**BUILDING 13  
SECTION F**

**PHOTOGRAPH #11**

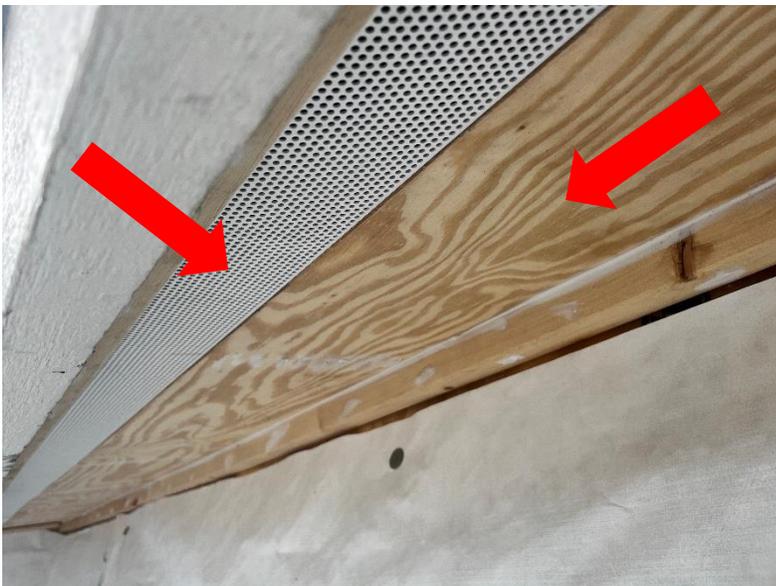
New sealants installed at base plate to foundation slab and base plate to new plywood sheathing as per drawings.
